Access Compliance Report Public Rights-of-Way (Curb Ramps)

Main Street: **FOOTHILL_BLV** Cross Street: **NEWPORT_AVE** Location: **SW**

ADA ID: **RPAT211018090252** Ramp Type: **Type 1 - Perpendicular Diagonal Initial Pass/Fail: Pass** Overall Compliance: **No** Severity Score: **5**

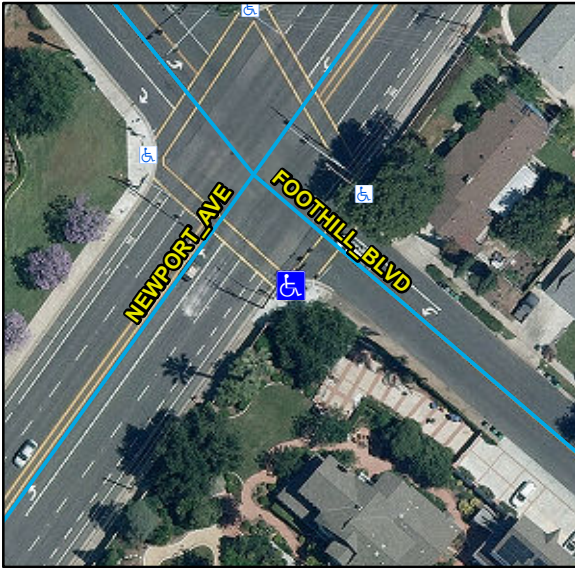
OC Std/PROW:
R304.2.2, R304.2.1, R304.5.4, STD 1115

Possible Solutions:
Remove & Replace Curb Ramp With Two New Directional Ramps or Equivalent. Remove & Replace Gutter.
